**AGENDA  
CITY OF ST. CHARLES  
PLAN COMMISSION  
CHAIR PETER VARGULICH**

Staff Report  
Plan Commission Meeting – June 4, 2024

**Fox Haven Square**

<b>Summary of Proposal:</b>	<p>Greco Investment Management LLC has filed zoning applications seeking approval to construct a commercial development on the vacant 7.5-acre parcel in the Stuart's Crossing PUD. The property is located south of the Jewel on Kirk Road. The proposed development includes:</p> <ul style="list-style-type: none"> <li>• Three restaurant/retail buildings clustered around a plaza at the east end of the site and pickleball/restaurant building at the south end.</li> <li>• Approx. 70,000 total building square footage.</li> <li>• Parking in front, along Kirk Road</li> <li>• Access from existing driveways off E. Main Street and Kirk Road.</li> <li>• Preserve existing cross-access drive through the property from Jewel to E. Main St.</li> <li>• New cross-access to the Charlestowne Mall property.</li> </ul> <p>A Concept Plan similar to the proposal was reviewed in Sept. 2023.</p>

SITE SIGNAGE

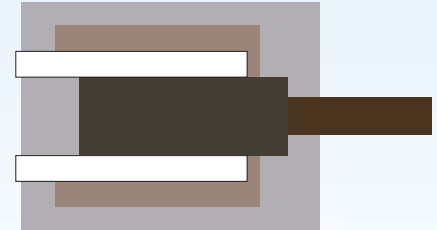
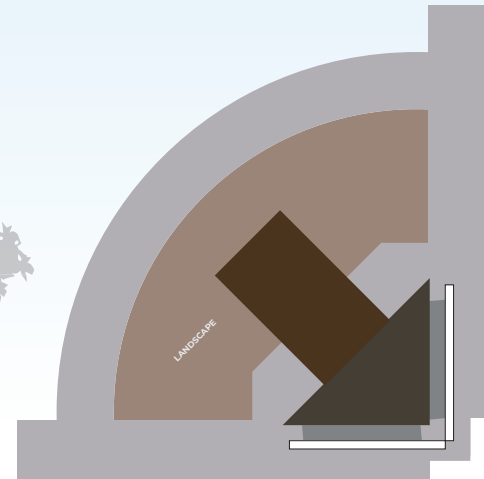
- ✓ The proposed sign at the corner of Main & Kirk is located within the 20 ft. site triangle. The sign will need to be pushed back, outside of the site triangle to allow for adequate motorist visibility.
- ✓ Dimensions of the sign facades are needed for all freestanding signs.
- ✓ The location of the sign at Kirk & Foxfield needs to be clarified on a scaled site plan. It appears that this sign will replace the existing Jewel sign at this corner, but this needs to be verified.

③ NORTH ELEVATION  
3/32" = 1'-0"

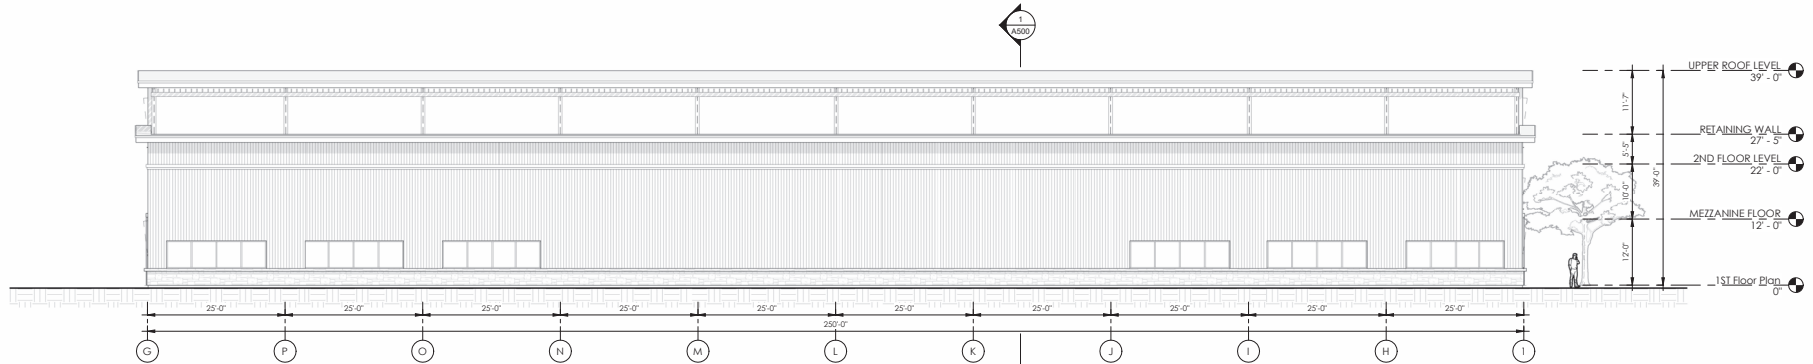
- a. Bldg 1: not met on the north elevation (side facing E-W access drive)
3. Roof lines should be varied with a change in height or incorporation of a major focal feature every 100 feet in building length.

- Create a more well-defined building entrance on the north elevation.
    - Provide additional articulation and interest through the addition of awnings and lighting.

- Consider doors with windows or storefront windows surrounding the barn doors.
    - Consider bumping out the building entrance to further accentuate the entrance and to provide consistency with Bldgs 1-3.
